Office Action Summary

10/800,710

DETAILED ACTION

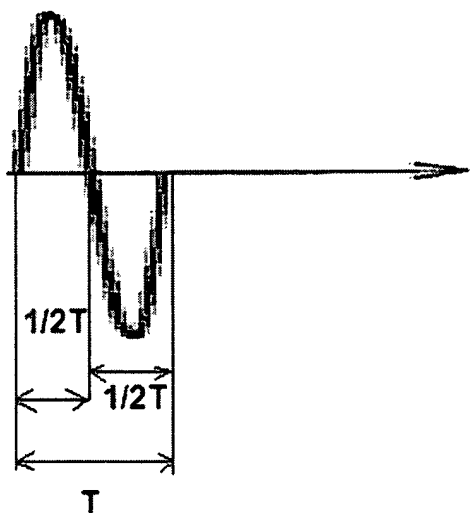
- and a determining unit determining presence *or* absence of sticking of said wafer; it is well known in the art that an exposure apparatus for semiconductor wafers will *always* have alignment means which detect the presence of the wafer and its position relative to a desired orientation, based on alignment marks on the wafer. If the alignment means do not detect the presence of a wafer, then with certainty no sticking has occurred. In general, Hara et al. discuss only the wafer supporting mechanism of a semiconductor processing apparatus such as an exposure apparatus shown schematically in Fig. 9. The presence of alignment means, however, can be inferred from the first step in Fig. 10 (fine-motion correction of wafer attitude completed). Such a step could not be completed without alignment means.
